Intel® Mobile Pentium® III Processor Specification Update

Release Date: July 2000

Order Number: 245306-009

Figure 7. BCLK Timing Waveform

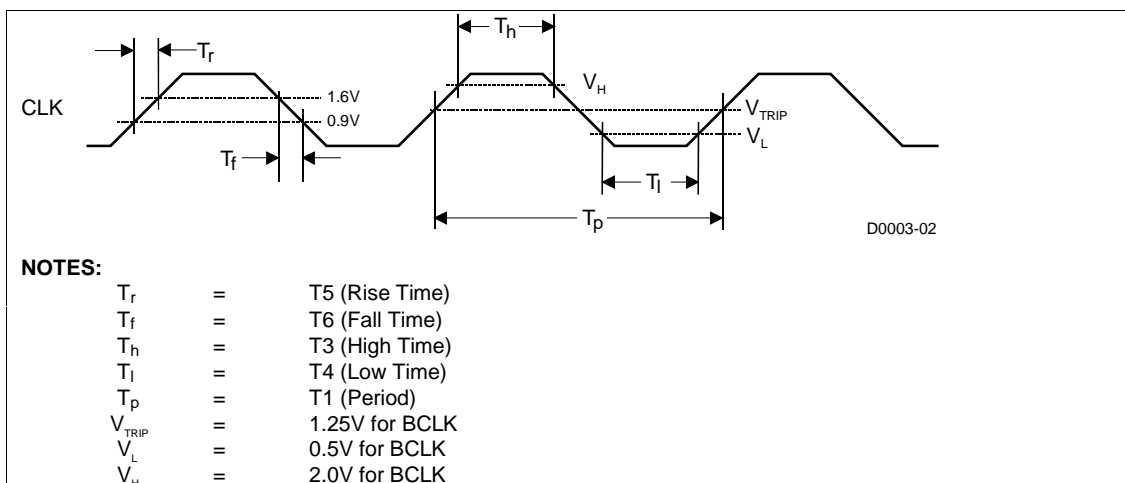
For B0 step processors, the $V_{IH,BCLK}$ Min spec is changed to 2.0V (from 1.7V for A2 step) and $V_{IL,BCLK}$ Max spec is changed to 0.5V (from 0.7V for A2 step). Due to this, new values are specified for BCLK high and low times for B0 step processors. These modifications affect corresponding specs in Table 13, Table 14, Table 24, and Figure 7 in *Mobile Pentium® III Processor in BGA2 and Micro-PGA2 Packages datasheet* (Order Number 245302-002).

The following tables and figures highlight the above mentioned BSEL[1:0] and BCLK specs modifications made for B0 step processors:

Symbol	Parameter	Min	Typ	Max	Unit	Figure	Notes
	System Bus Frequency		100		MHz		
T1	BCLK Period		10		ns	Figure 7	Note 2
T2	BCLK Period Stability			± 250	ps		Notes 3, 4
T3	BCLK High Time	2.70			ns	Figure 7	at >2.0V
T4	BCLK Low Time	2.45			ns	Figure 7	at <0.5V
T5	BCLK Rise Time	0.175		0.875	ns	Figure 7	(0.9V – 1.6V)
T6	BCLK Fall Time	0.175		0.875	ns	Figure 7	(1.6V – 0.9V)
